ADDENDUM NUMBER TWO

**Langan Park – Amphitheater Pavilion & Restroom
Project No: PR-031-21**

**Public Safety Memorial Park
Restroom, Skateboard Park & Splashpad**

OCTOBER 24, 2022

TITLE SHEET,
DRAWING INDEX,
SITE PLAN &
WORK AREAS

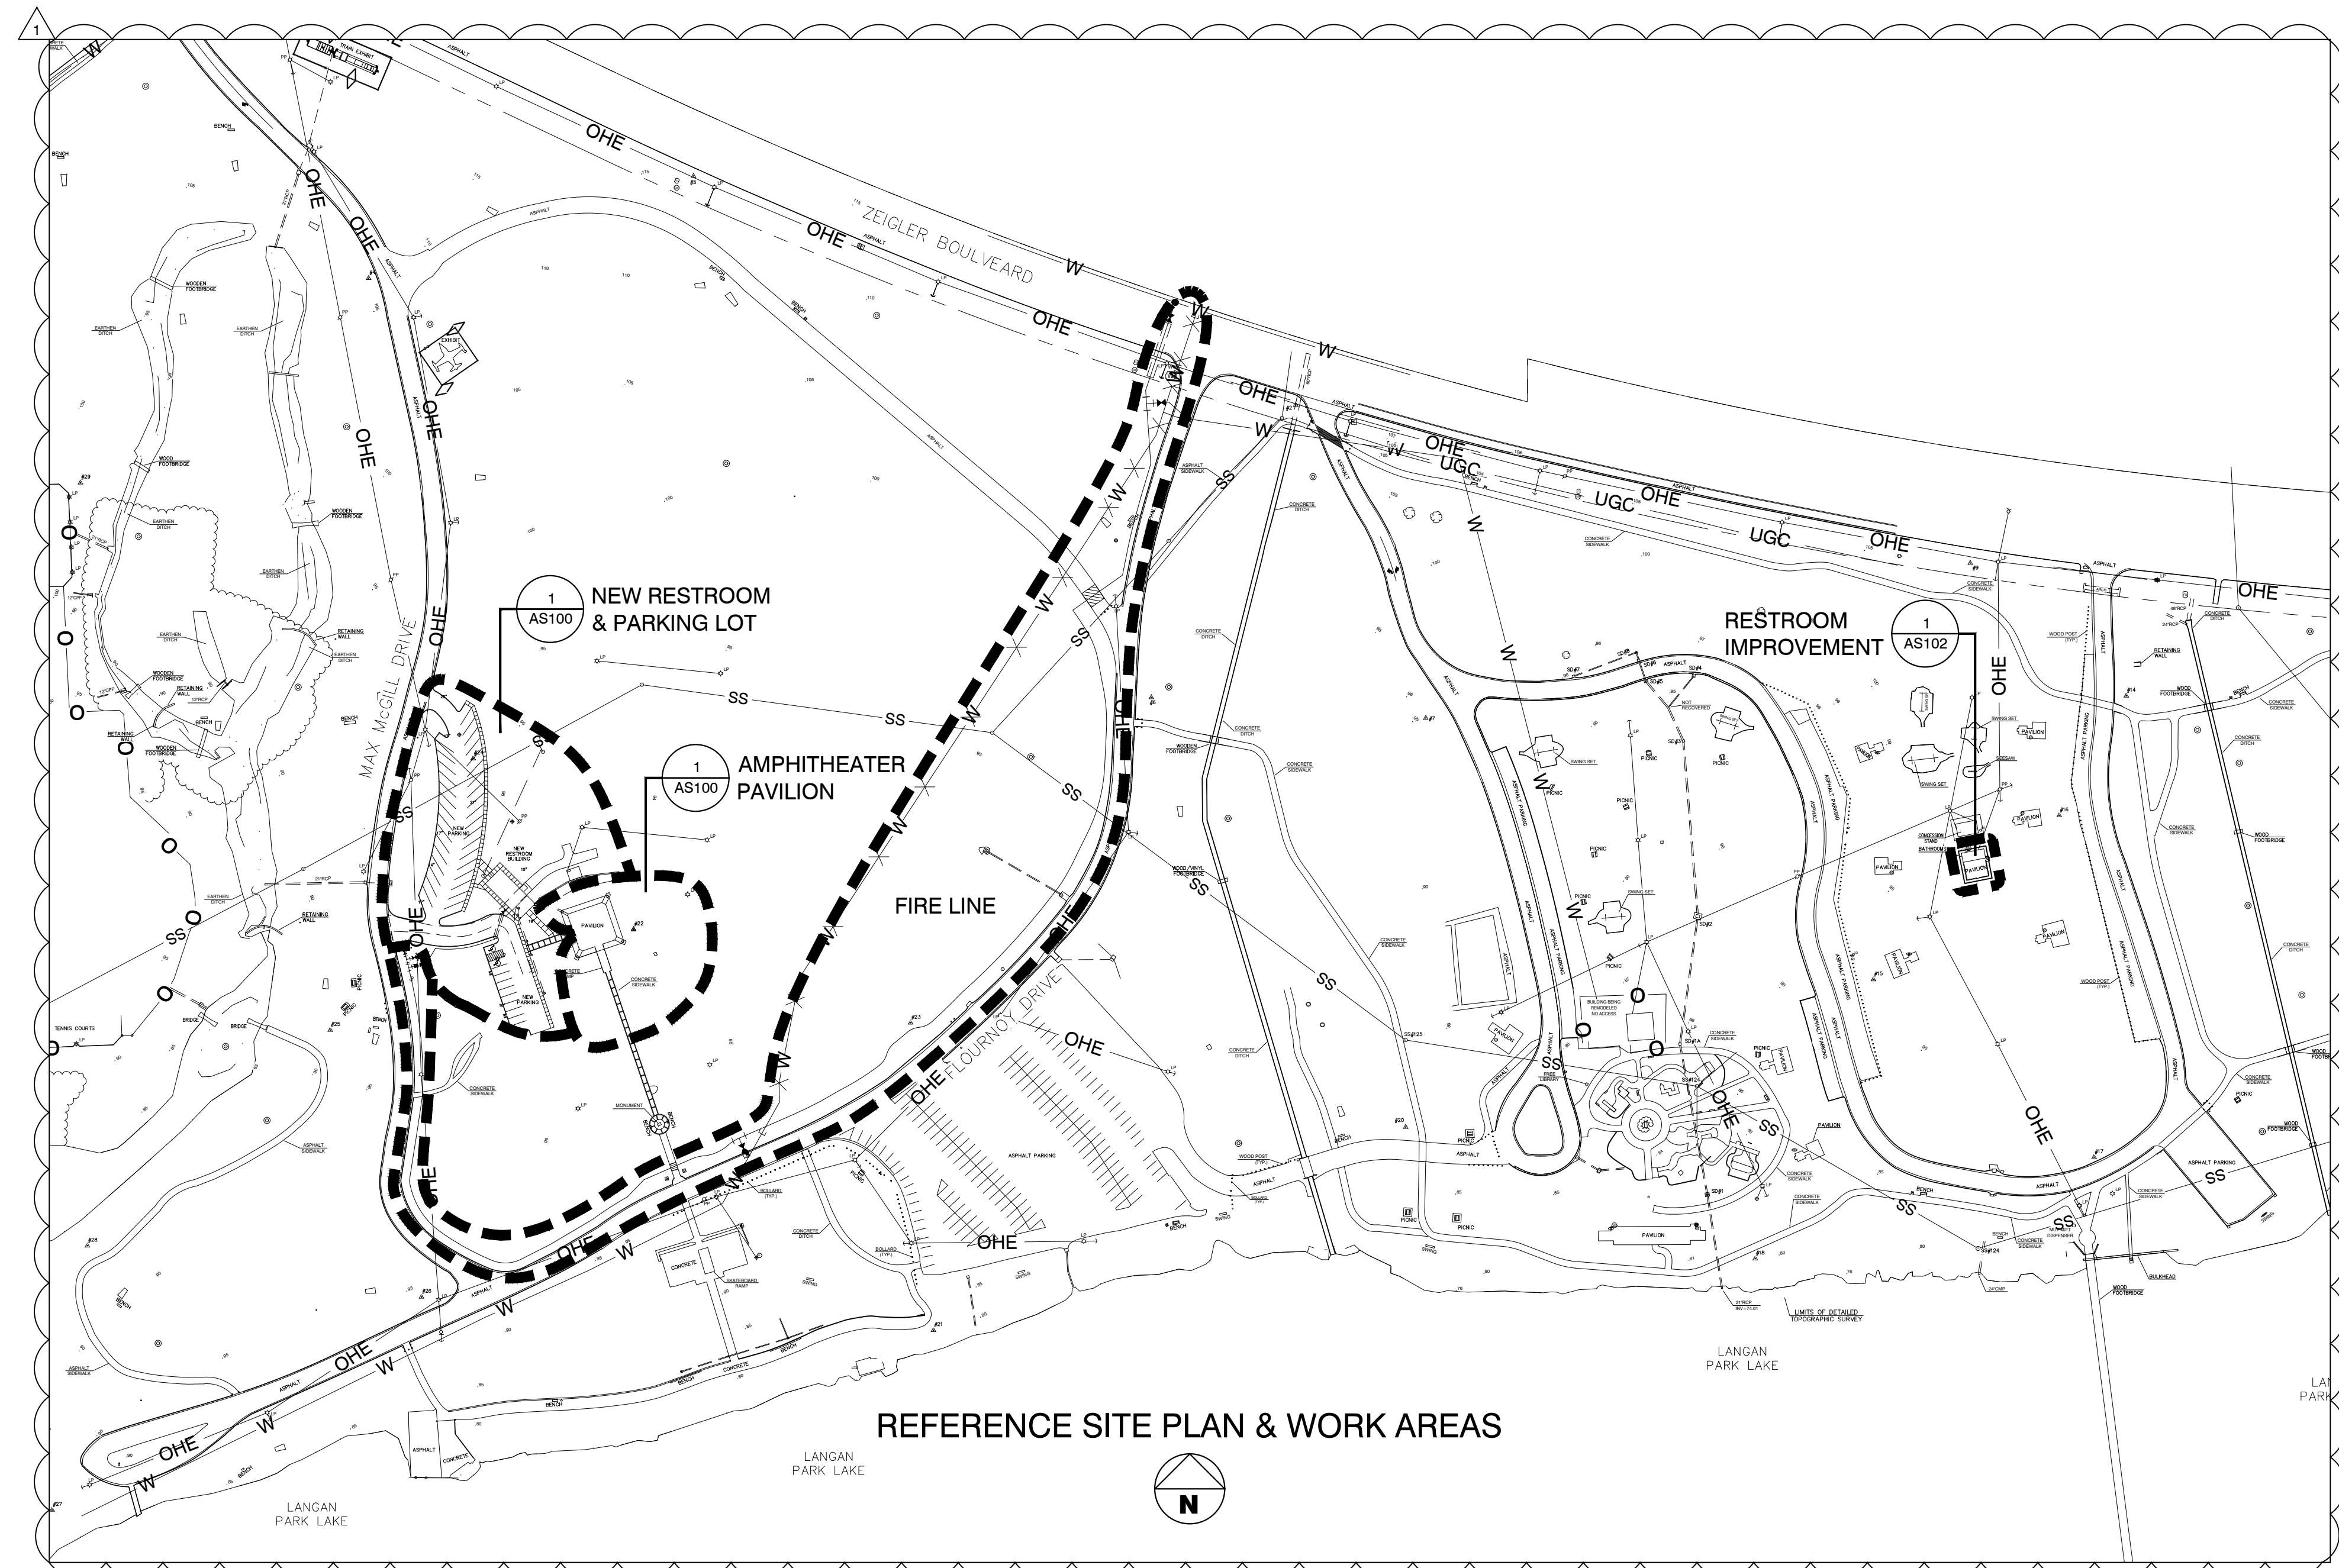
- 4.01 Revised General Drawing Index:
- A. Replace G001 with attached *new G001 - Title Sheet, Drawing Index, Vicinity Map*, Addendum 02 dated October 24, 2022. Changes made to site map to include work areas to conform to Bid Form Area Base Bids.

SHEET TITLE
 SYMBOLS,
 ABBREVIATIONS,
 GENERAL NOTES

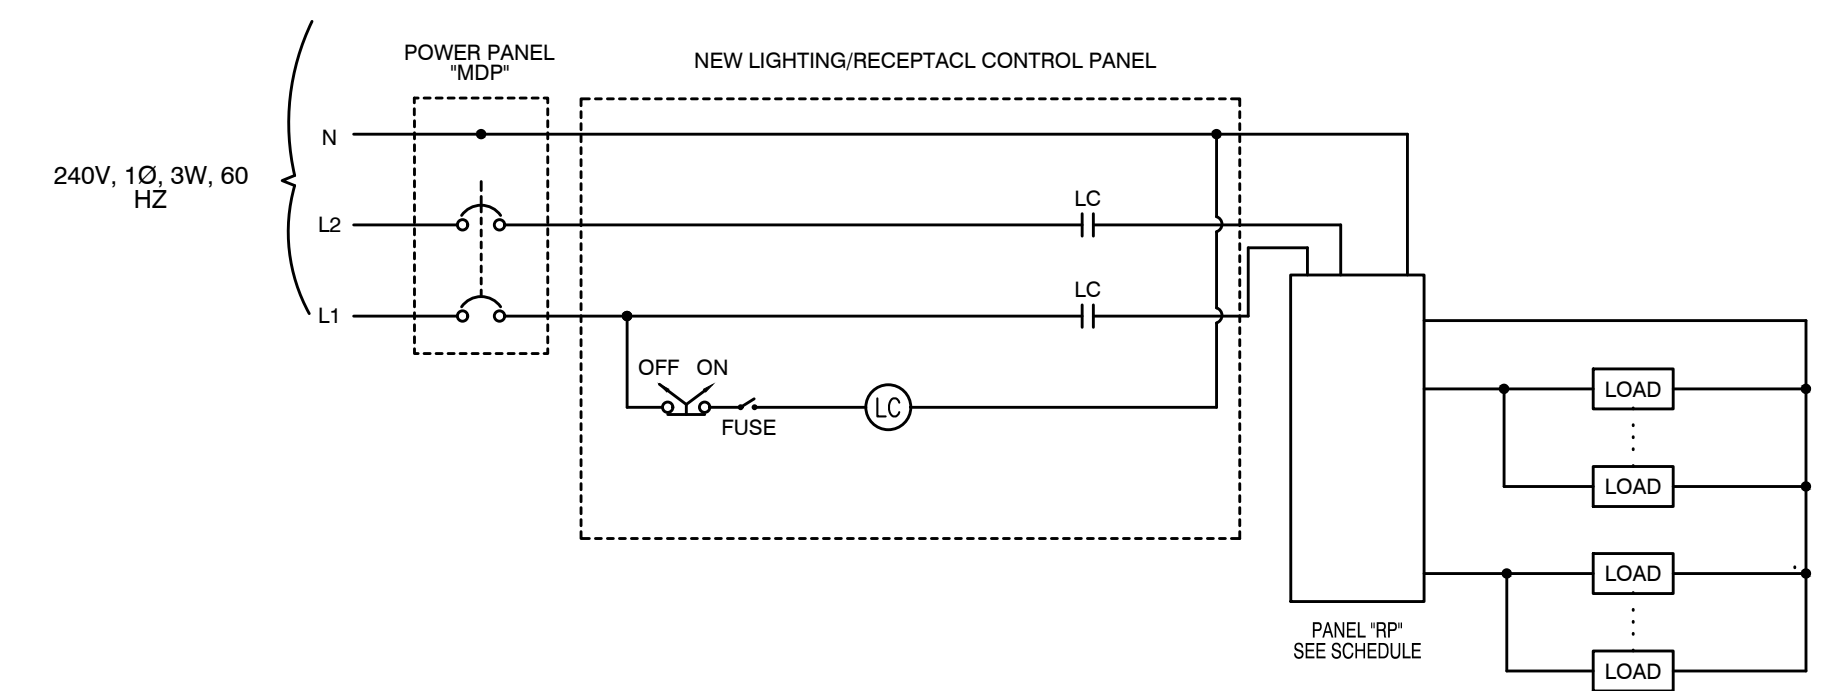
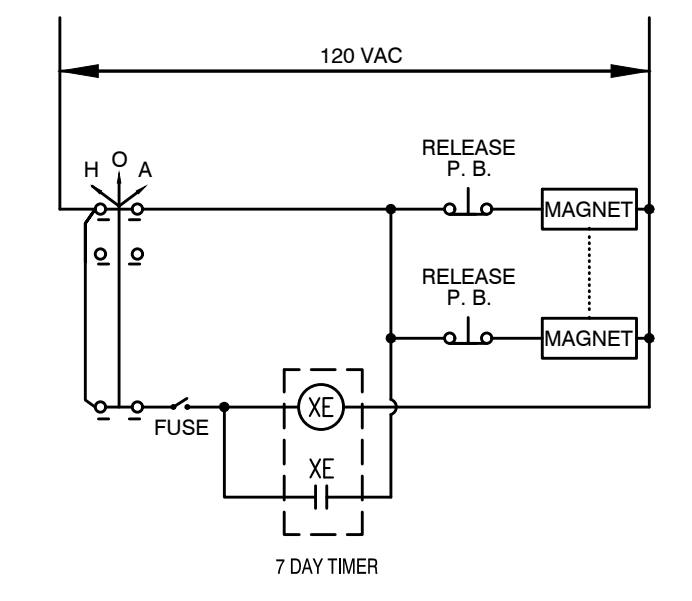
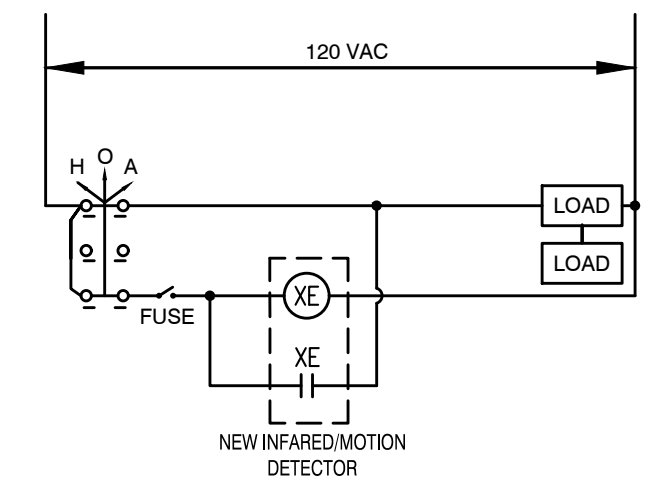
- 4.02 Reference *Attached Drawing E-100* – Symbols, Abbreviations, General Notes for the following changes:
- A. The Light Fixture Schedule shall be revised. The *Fixture "E"* catalog number shall be changed from a Lithonia Catalog No. DSXSC LED 30C 700 50K T5WMVOLT DMG to *Lithonia Catalog No. DSXSC LED 30C 700 50K T5WMVOLT DMG-PIR*. The fixture shall dim to 30% of output during times without motion and daylight until motion is detected, then the fixture shall ramp up to full output.

- B. The Light Fixture Schedule shall be revised to add *Fixture "E1"*. *The fixture shall be a U.S. Architectural Catalog No. DSDP25-PLED-VSQ-M-36LED-1050mA-NW-VOLT RAL-XXXX-T-SM+L-HLSW*.
